## CASE01 Pretrial Trial01 Water Level 3.5 WL= 2.1 m, Hs= 0.6 m, T= 7.11 s 1 0.5

## My plot

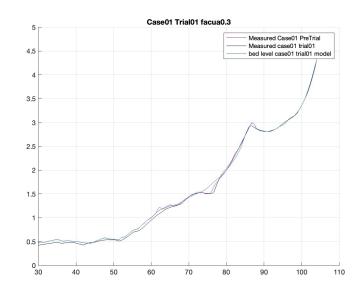
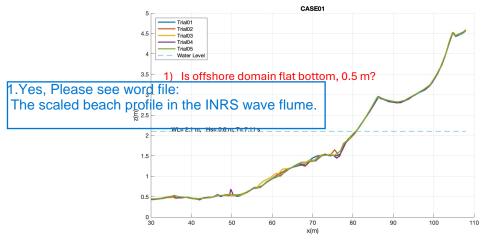
The profile in your plot looks smoother than the raw data. Did you use any filtering?

Please see Smoothed\_Profles folder.

Previous Profiles all cleaned and smoothed but for having smoother ones I used "moving method, span=21"
